UNITED STATES
NUCLEAR REGULATORY COMMISSION
WASHINGTON, D.C. 20555-0001

SUBJECT: RESOLUTION OF DEGRADED CEQ FAN ROOM WALL

Discussion of Containment
Subcompartment Walls

NRC STAFF QUESTIONS CONCERNING OPERABILITY OF

Description of the Issues: Grout Strength

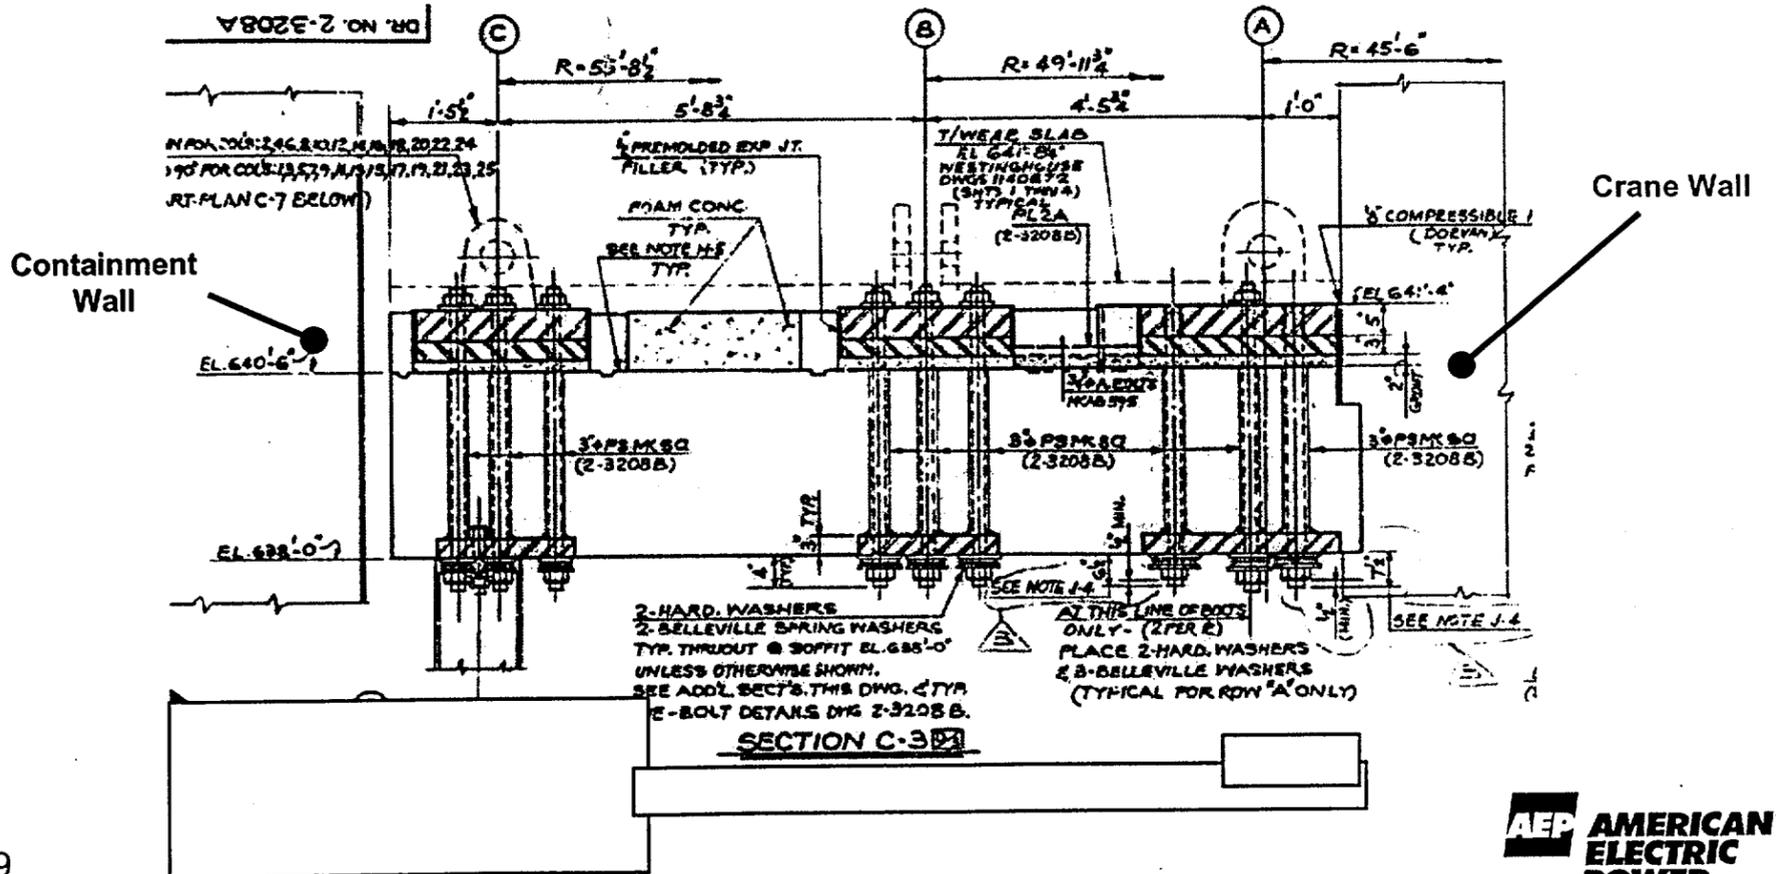
- **Spalling Discovered During System Readiness Reviews**
 - Grout discovered during repair
- **Top of 126° and 307° Walls Grouted**
 - 126° wall due to ice condenser structure interference
 - 307° wall due to construction sequence - installed after ice condenser slab poured
- **Grout Strength**
 - Estimated as 1000 psi in 126° wall
 - Tested in 307° wall: 1,280, 1,770, and 4,380 psi

■ Detail Showing Pocket for Anchorage Through Bolts

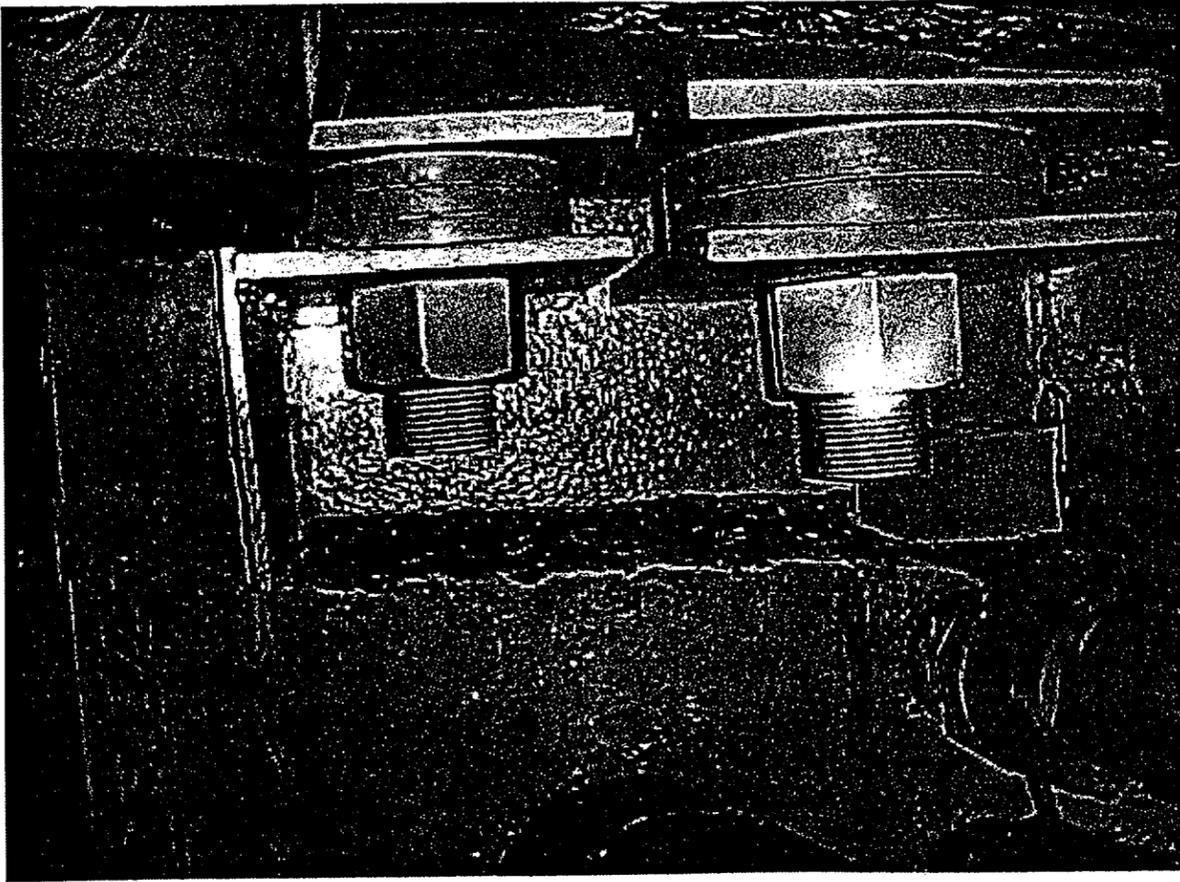
- **Pockets at Top of 126° Wall for Bolting**
- **Design Required Pockets to be Grouted**
- **Pockets Left Open From Original Construction**
